Subject: Acton Town Council Comments on the Draft Decision Issued by the Office of Electrical Infrastructure Safety to Approve Southern California Edison Company's 2026-2028 Base Wildfire Mitigation Plan.

Reference: Docket #2026-2028-Base-WMPs.

**COMMENTS SUBMITTED BY THE ACTON TOWN COUNCIL
TO THE CALIFORNIA PUBLIC UTILITIES COMMISSION ON
SCE PSPS POST EVENT REPORTS.**

Figure 1. Bootlegger Circuit Map Showing Locations of Distribution Weather Stations.

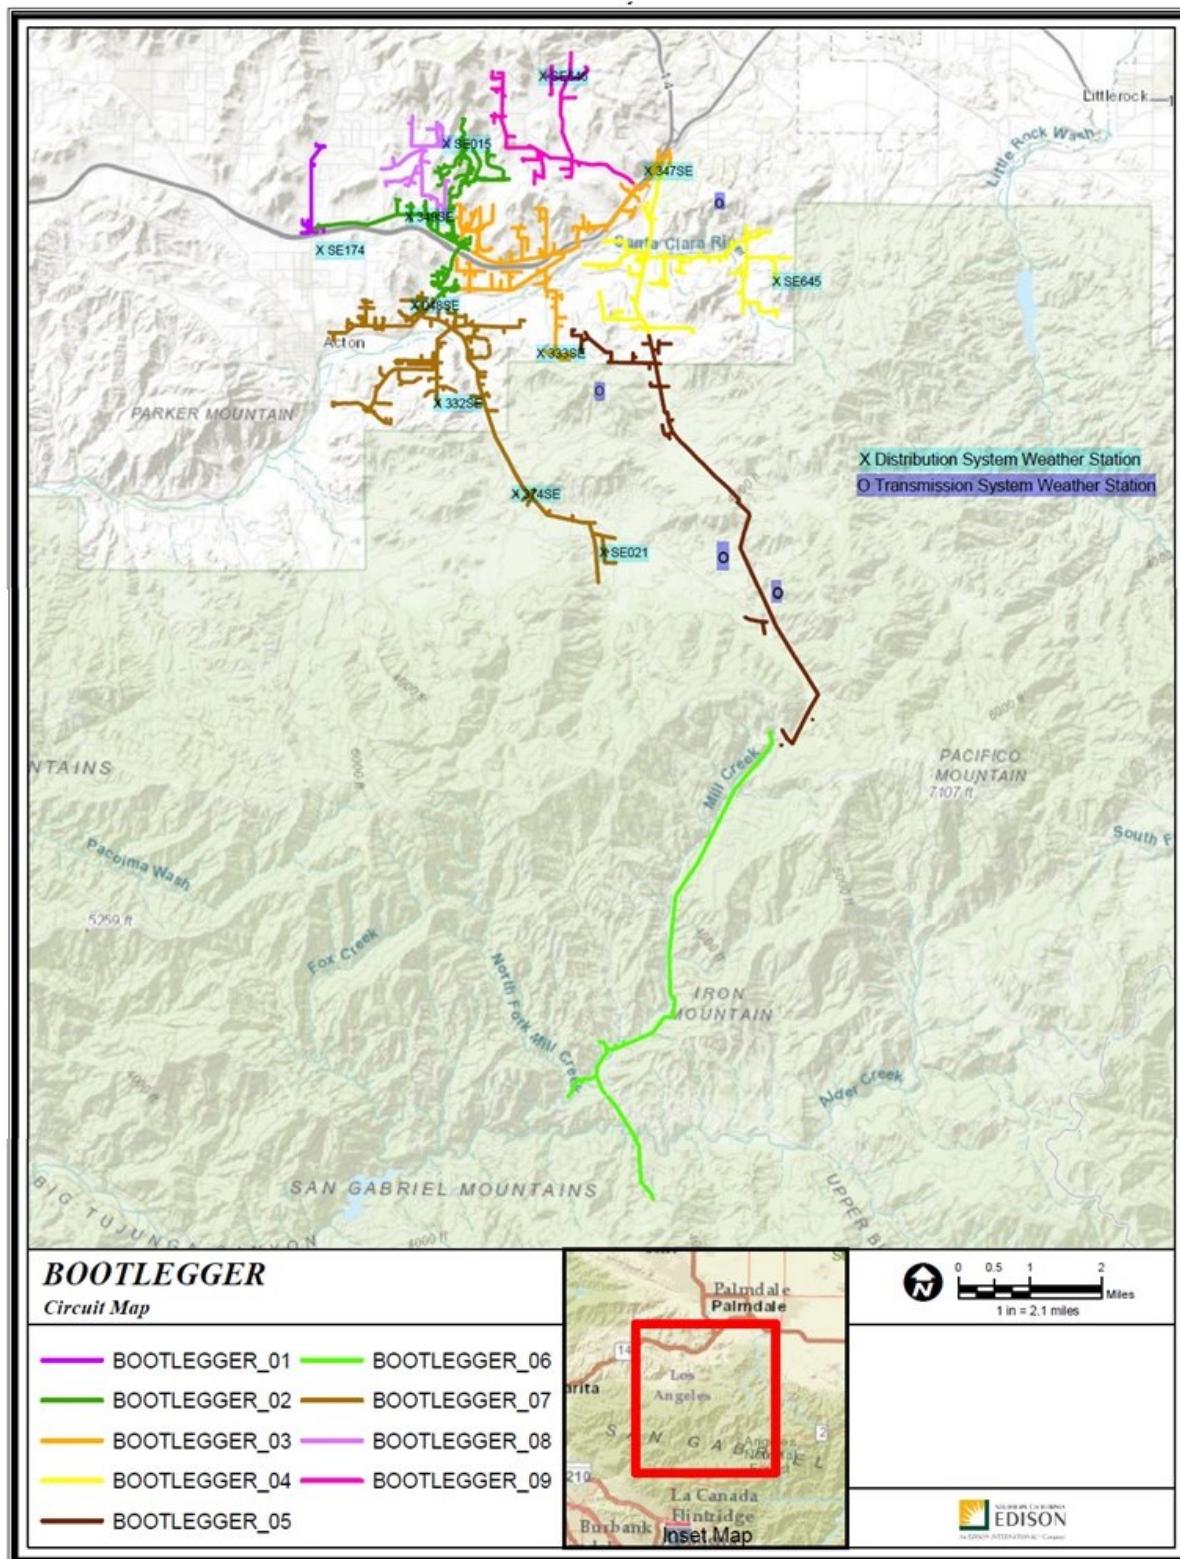
The Bootlegger Circuit The Council has carefully mapped the location of all SCE weather stations in the portion of Acton served by the Bootlegger distribution circuit; this map is provided in Figure 1. Note: some of the weather stations identified on this map are on transmission facilities located on ridgelines and are not on distribution facilities; these transmission facility weather stations are indicated with a different color. This map enabled the Council to identify all SCE weather stations that monitor conditions on the Bootlegger distribution circuit and download weather data from these stations for the duration of power shutoffs during the PSPS event that began on January 2. This weather data was then reconciled with SCE's power shutoff notices to precisely ascertain the weather conditions on each segment of the Bootlegger circuit before and after it was shutoff. The results of this analysis are summarized in Table 1 which shows that the Bootlegger distribution circuit did not experience wind conditions that met or exceeded SCE de-energization thresholds either during the 12 hour period *before* power was shutoff or during the 12 hour period *after* power shutoff. Accordingly, *none* of the power shutoffs that SCE initiated on the Bootlegger circuit during the January 2 PSPS event were warranted and *none* of them complied with SCE's own PSPS protocols which expressly limit power shutoffs to only circumstances in which the FPI threshold is exceeded AND a wind threshold is exceeded.

⁴ According to Section 2 on page 79 of SCE's PSPS Post Event Report Dated December 30, 2024, SCE cut power on the Bootlegger circuit based on a claim that the circuit experienced a 59.04 mph wind gust on December 9. However, a review of the data collected by the distribution weather stations identified in Figure 1 do not indicate any wind gust measurements exceeding 55 mph. However, data collected by the Transmission Weather Station No. 555SE located on top of a 500 kV transmission tower on a ridgeline in the Angeles Forest does indicate that a 59 mph gust hit the transmission tower on December 9. Therefore, the Council assumes that this transmission tower measurement was used to justify power shutoffs to Acton residents located many miles away.

Figure 2. Shovel Circuit Map Showing Locations of Distribution Weather Stations.

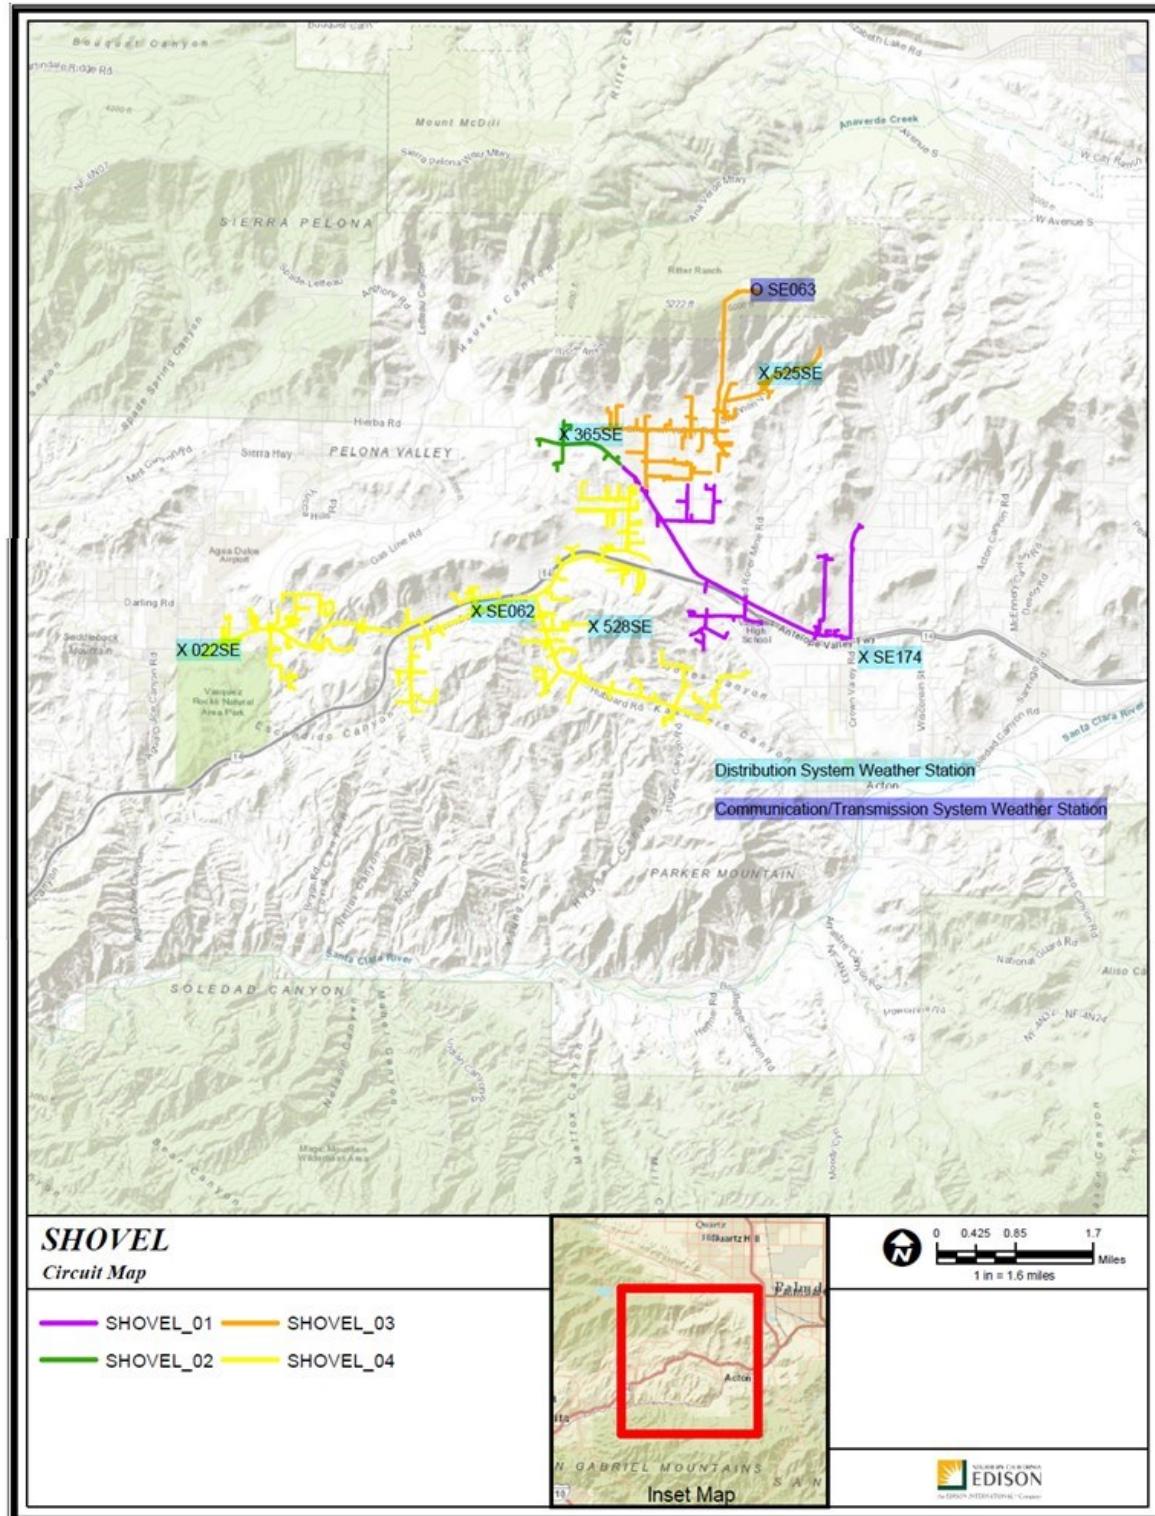
The Shovel Circuit: The Council carefully mapped the location of SCE weather stations in the portion of Acton served by the Bootlegger distribution circuit. This map (provided in Figure 2) enabled the Council to identify all SCE weather stations that monitor conditions on the Shovel circuit and download weather data from these stations for the duration of the January 2 PSPS event. This weather data was then reconciled with SCE's power shutoff notices to precisely ascertain the weather conditions on each section of the Shovel circuit before and after it was shutoff. The results of this analysis are summarized in Table 2 which shows that the Shovel circuit never experienced any wind conditions which met or exceeded SCE de-energization thresholds either during the 12 hour period *before* power was shutoff or during the 12 hour period *after* the power shutoff. Accordingly, *none* of the power shutoffs that SCE initiated on any segments of the Shovel circuit during the January 2 PSPS event were warranted and *none* of them complied with SCE's own PSPS protocols which expressly limit power shutoffs to only circumstances in which the FPI threshold is exceeded AND a specific wind threshold is exceeded.

Figure 3. Pick Circuit Map Showing Locations of Distribution Weather Stations.

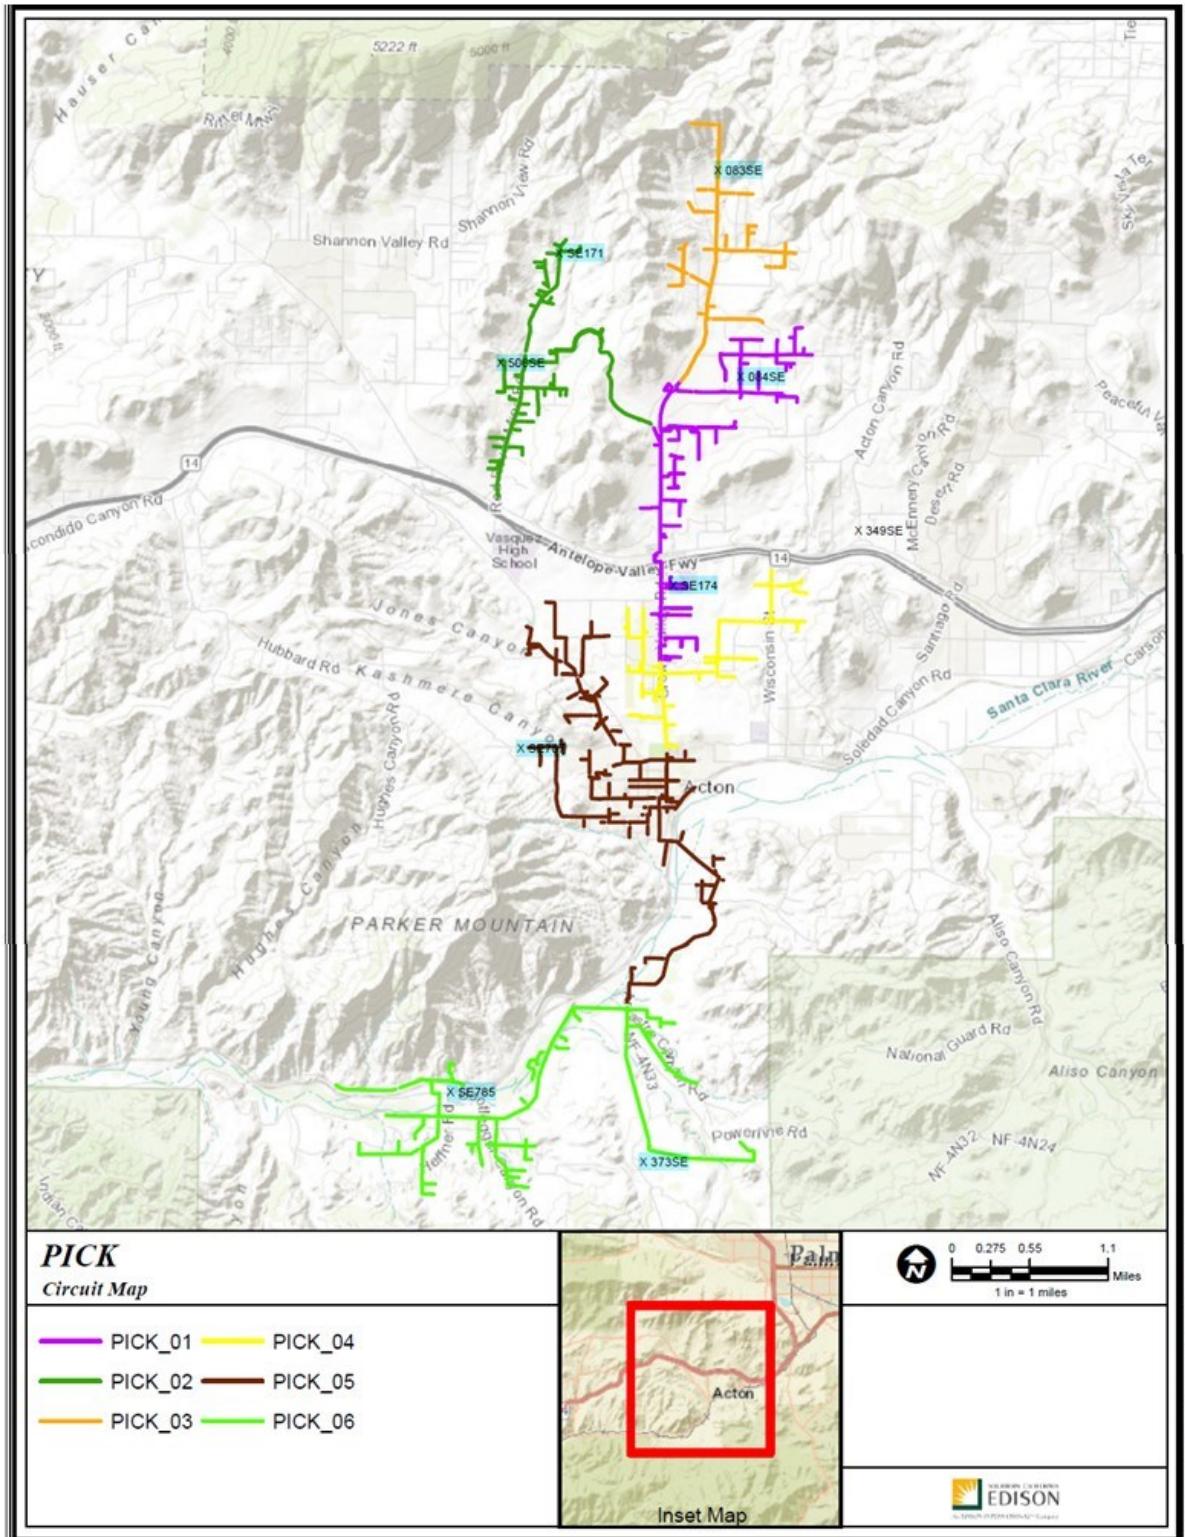
The Pick Circuit The Council carefully mapped the location of SCE weather stations in the portion of Acton served by the Pick distribution circuit. This map (provided in Figure 3) enabled the Council to identify all SCE weather stations that monitor conditions on the Pick circuit and download weather data from these stations for the duration of the January 2 PSPS event. This weather data was then reconciled with SCE's power shutoff notices to precisely ascertain the weather conditions on each section of the Pick circuit before and after it was shutoff. The results of this analysis are summarized in Table 3 which shows that the Pick circuit never experienced any wind conditions which met or exceeded SCE de-energization thresholds either during the 12 hour period *before* power was shutoff or during the 12 hour period *after* the power shutoff. Accordingly, *none* of the power shutoffs that SCE initiated on the Pick circuit during the January 2 PSPS event were warranted and *none* of them complied with SCE's own PSPS protocols which expressly limit power shutoffs to only circumstances in which the FPI threshold is exceeded AND a specific wind threshold is exceeded.

SCE has assigned an "FPI De-energization Threshold" of only 12 for the Pick and Shovel circuits, and SCE's January 2 Post Event Report claims that these thresholds were exceeded; however, the Council is unable to confirm this claim because SCE has refused to provide the requested parametric data needed to do so. This is quite troubling, given that SCE's Post Event Reports are required to address "all factors considered in the decision to shut off power" (Resolution ESRB-8, pp.3-4) and given that the parametric data were explicitly used by SCE to calculate FPI values in real time during the PSPS event and are therefore "factors considered in the decision to shut off power". In fact, these factors form the sole basis for SCE's pre-determined FPI de-energization thresholds AND its calculated FPI values.

Figure 4. Pick Circuit Section with Full Underground Service from Acton Substation.

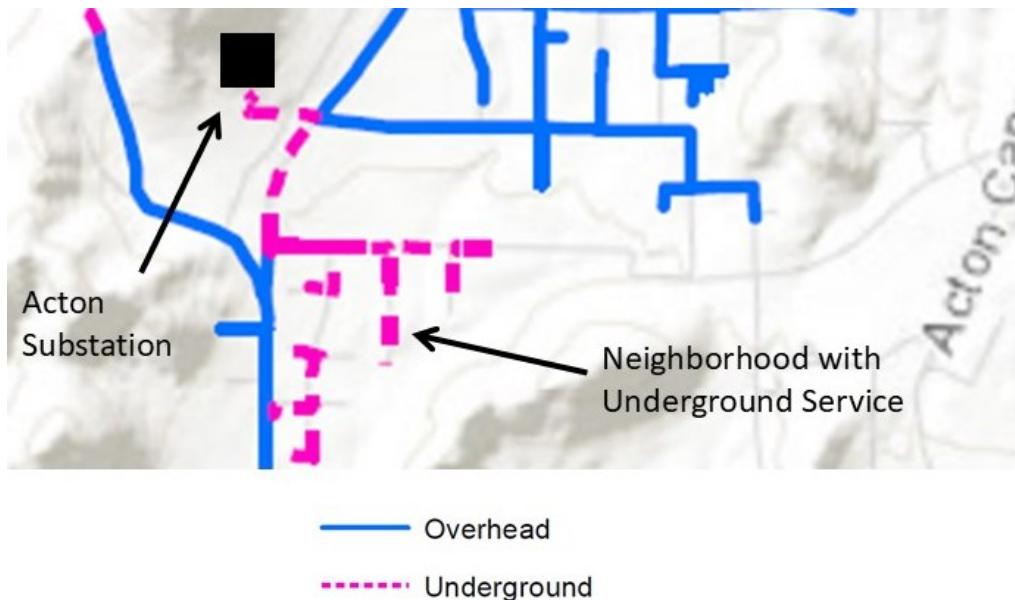
SCE has failed to sectionalize an entire neighborhood in Acton that has electrical service which is never affected by weather events because it is 100% underground from the Acton substation. The Council has pointed this out to SCE many times since SCE’s first PSPS events in 2019, but SCE has chosen not to sectionalize the area. We have also pointed out this significant deficiency to the Commission many times in our comments that we have filed in response to SCE Post PSPS Event reports and in our submissions in Proceeding I.19-11-013; unfortunately, the Commission ignored these concerns as well. SCE is aware that this neighborhood has full underground service; in fact, SCE recently provided the map depicted in Figure 4 which shows that the neighborhood has only underground service from the Acton Substation.

Figure 5. Residential Area on the Bootlegger Circuit that has not been Sectionalized and is Routinely De-Energized based on Erroneous Wind Data Collected from Atop Transmission Towers on Ridgelines Located Miles Away.

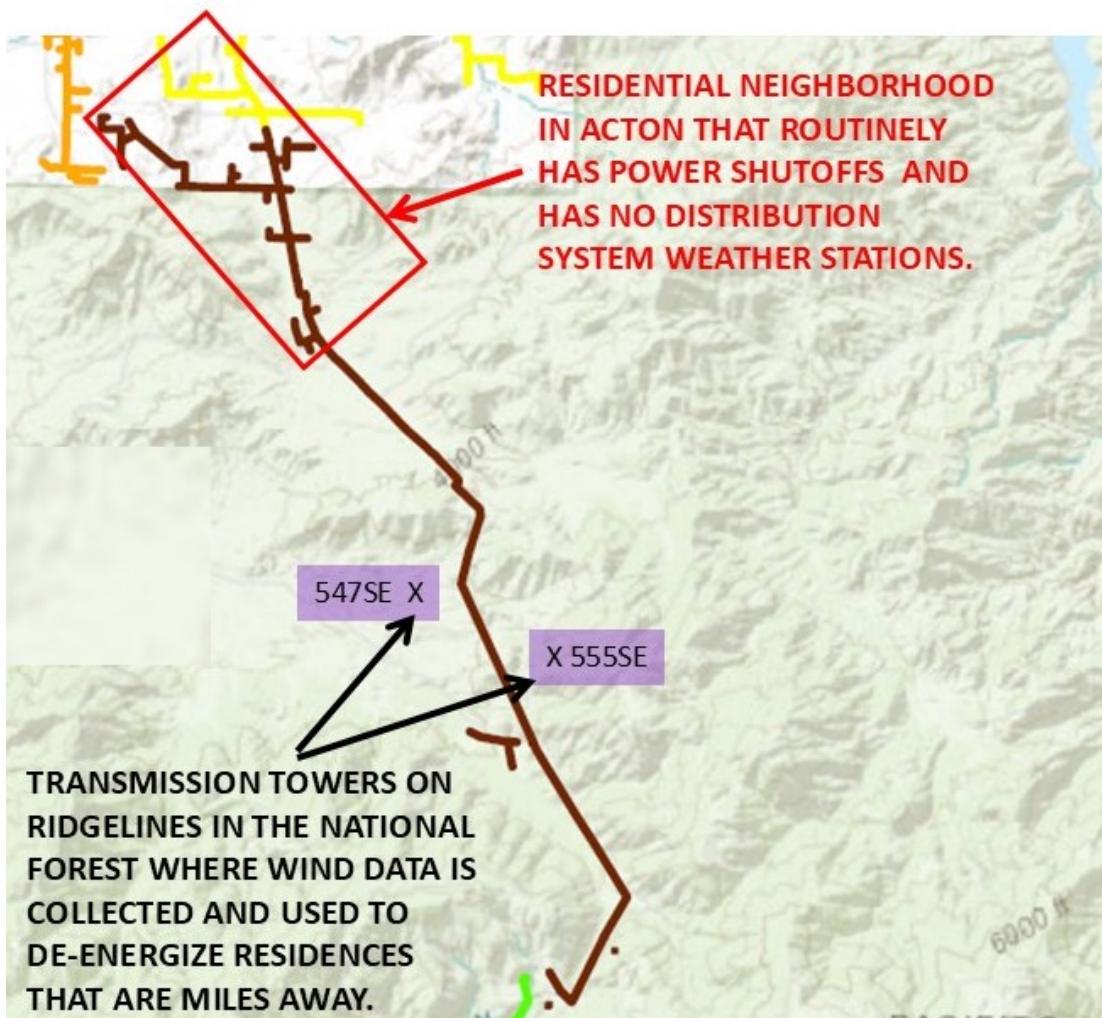
SCE has also failed to sectionalize a large residential area in Acton on Segment 5 of the Bootlegger circuit which experiences frequent and lengthy de-energizations based on *transmission system* wind measurements taken on top of 500 kV transmission towers located on high ridgelines miles from the homes where power is shutoff (as explained above). As shown in the map provided in Figure 5, SCE has not segmented a large residential area on the north end of Segment 5; this area has no dedicated distribution system weather stations, so SCE shuts off power to this neighborhood based on wind measurements collected on transmission facilities located on a ridgeline several miles south and deep into the Angeles National Forest. As a result, SCE routinely de-energizes Acton residents based on inapplicable wind data that does not represent *actual* wind conditions on the distribution circuit in the areas that are de-energized. All of this is improper and it violates the Commission's directive to continually reduce the scope and extent of PSPS events by sectionalizing circuits.

Figure 6. Residential Area on the Shovel Circuit that has not been Sectionalized and is Routinely De-Energized based on Erroneous Wind Data Collected from Atop Communication Towers located on Ridgelines High Above.

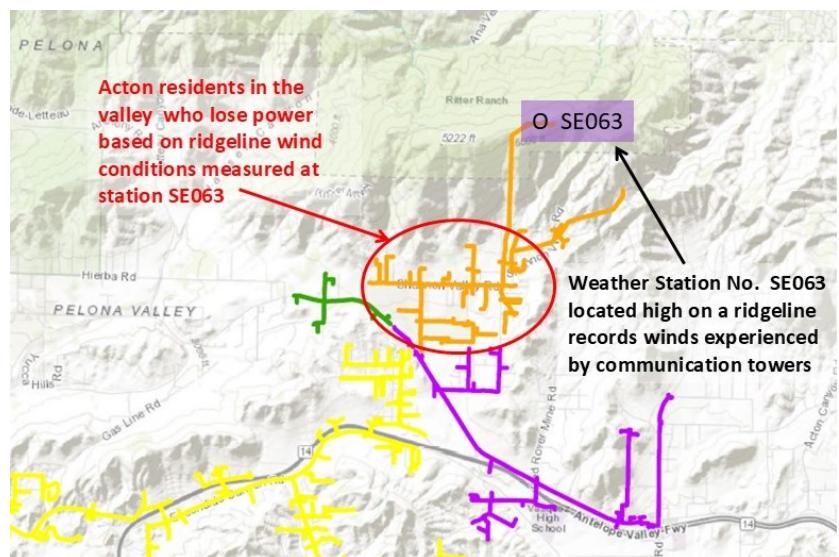
SCE has also failed to sectionalize a large length of the Shovel circuit that only energizes telecommunication equipment located high on a ridgeline (at elevation 5,124 ft¹³) and which experiences relatively high wind speeds because of its ridgeline location. Worse yet, SCE has deployed a weather station on the cell tower facilities located on this ridgeline (station No. SE063) and it appears that SCE uses the weather data collected on

this ridgeline to de-energize homes located in the valley far below (as shown in Figure 6). SCE should have sectionalized that portion of the Shovel circuit years ago and installed a weather station in the valley to properly measure the actual, local wind conditions that residents experience. Acton residents pointed this out in workshops that SCE hosted in 2020 and 2021; nothing was done. UPDATE: On March 17, 2025, SCE provided the Council with a new map of the Shovel circuit showing that the portion of the Shovel Circuit that serves the ridgeline communication facilities has been sectionalized. That is appreciated. However, the fact remains that this sectionalization was not completed before SCE initiated the January 2, 2025 PSPS event and therefore these concerns regarding SCE's sectionalization failures remain valid.

Figure 7. Map of Red Rover Mine Road Neighborhood Depicting Locations of Weather Stations and Showing Residential Areas that Should be Sectionalized.

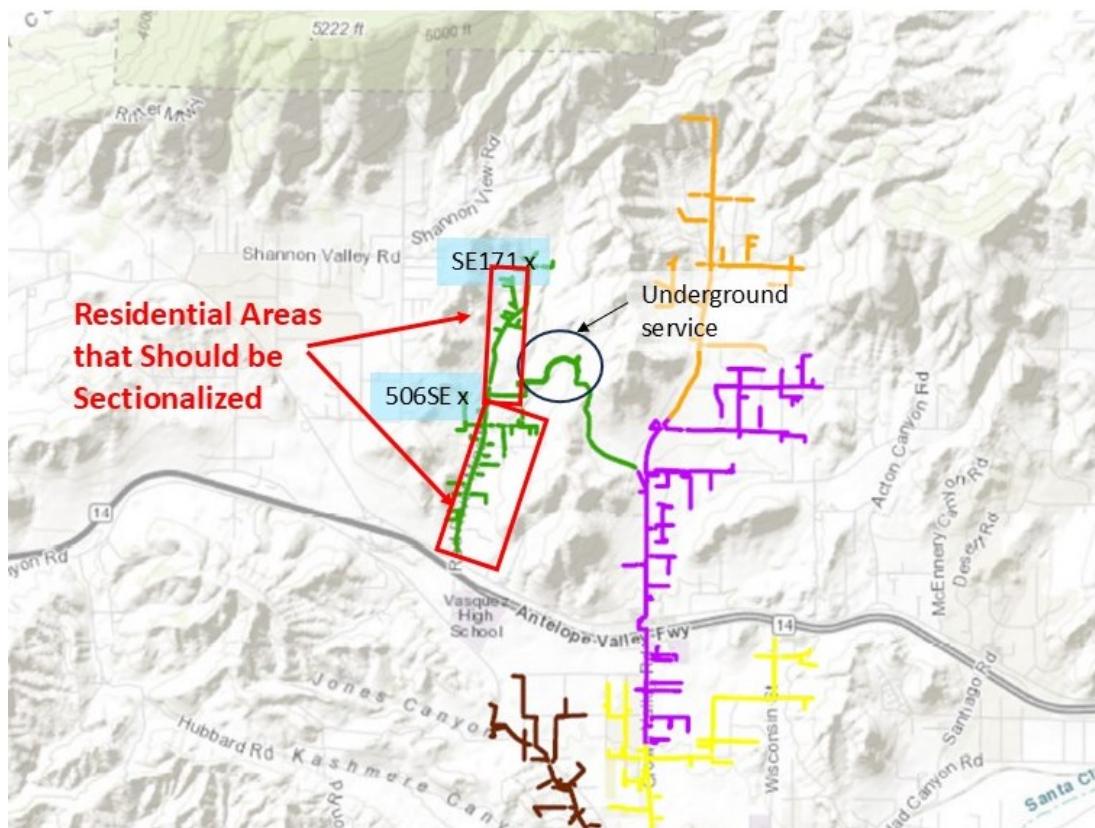
Additionally, SCE should have sectionalized the west side of Pick Circuit Segment 2 that serves Red Rover Mine Road from the east. SCE maintains two weather stations along Red Rover Mine Road (which is a long, shallow, broad, north-south running canyon with many homes): Station No. SE171 is on the north end and Station No. 506SE is located high on the west side of the Canyon near a narrow gap in the hills where (of course) windspeeds are higher (not only because Station No. 506SE is higher up but also because windspeeds increase as they approach and pass through the narrow gap¹⁴). In other words, the wind speeds measured by weather station No 506SE only represent very localized conditions experienced by just a few residences on the west side of the canyon near the gap and do not reflect wind conditions anywhere else on Pick Segment 2 (see Figure 7). SCE's own weather data prove this to be true: during the wind events in January, 2025, Station No. SE171 on the north end recorded windspeeds that were consistently at least 30% lower than wind speeds recorded by Station No. 506SE. Nonetheless, SCE cuts power *everywhere* along Red Rover Mine Road based on windspeeds measured by Station No. 506SE. This is completely inappropriate.
